<b>HERSCHEL/PLANCK</b>	REF. : HP-ASPI-MN-390	
		DATE : 25/09/01	PAGE : 1/10
<b>MINUTES OF MEETING</b>		PLACE : RAL / UK

PURPOSE :	CLASSIFICATION :
<b>SPIRE – Technical Meeting n° 2</b>

# HERSCHEL SVM - PANEL - Z LAYOUT - STUDY N+1

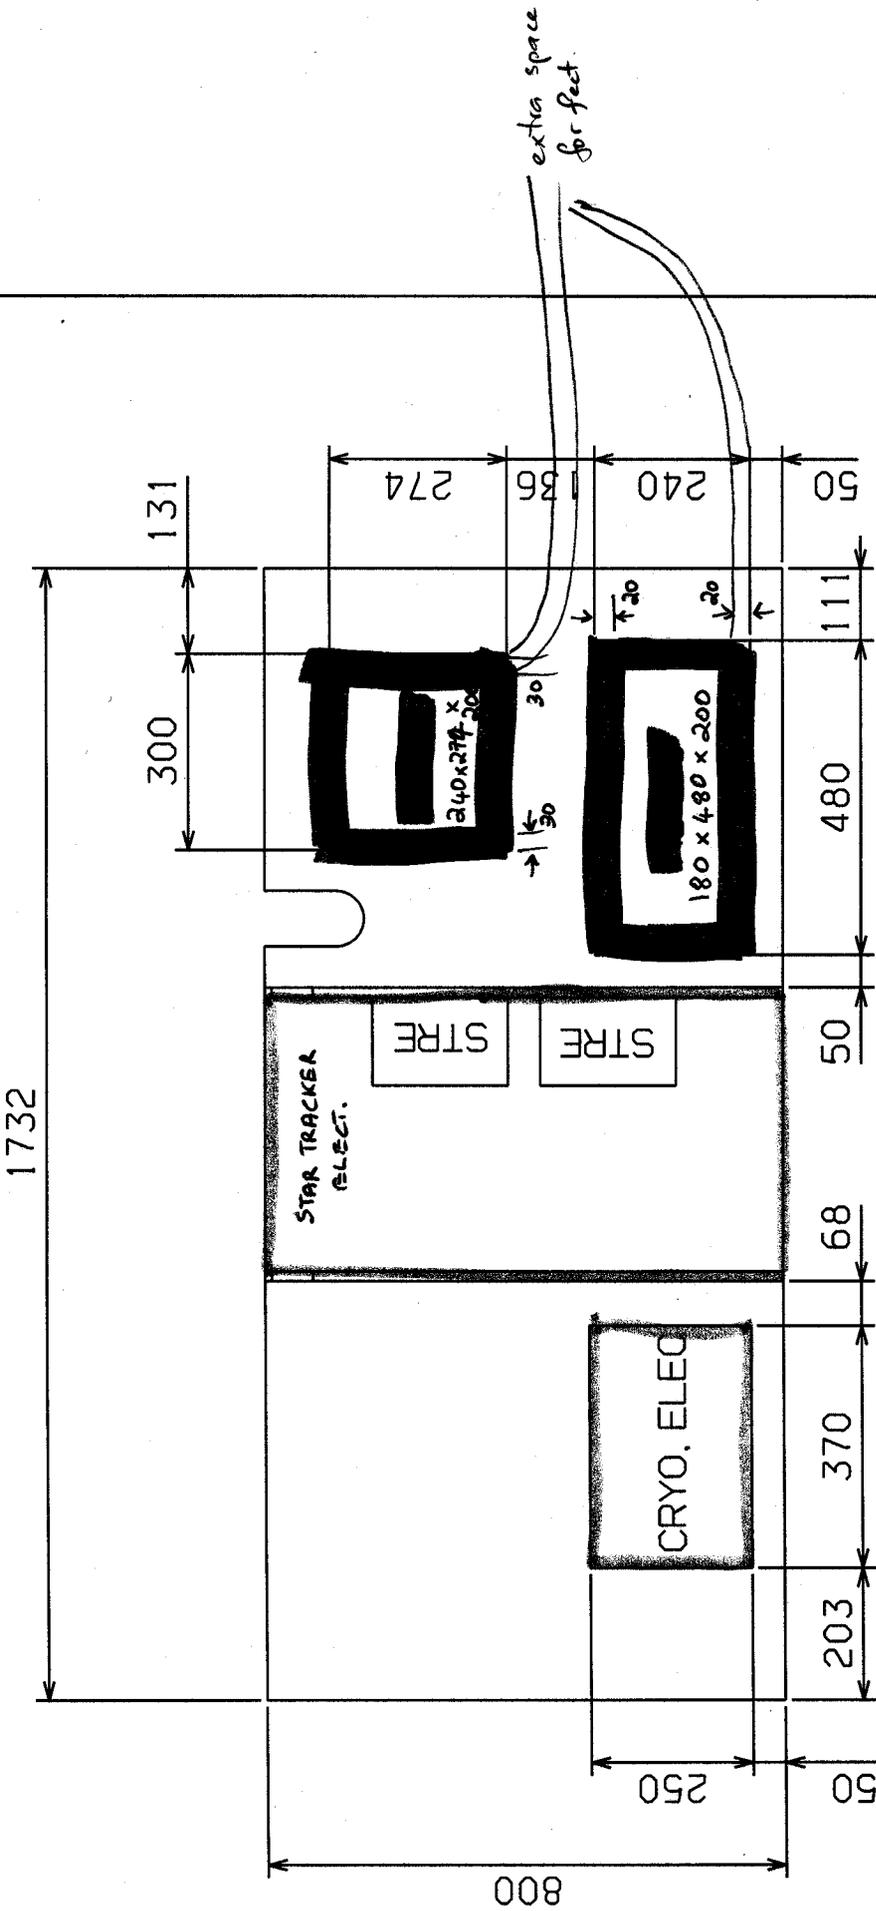
- Confirm box dimensions
- Need connector locations & characteristics
- Design assuming HSFCL = HSFCL + HSDCL = 760x
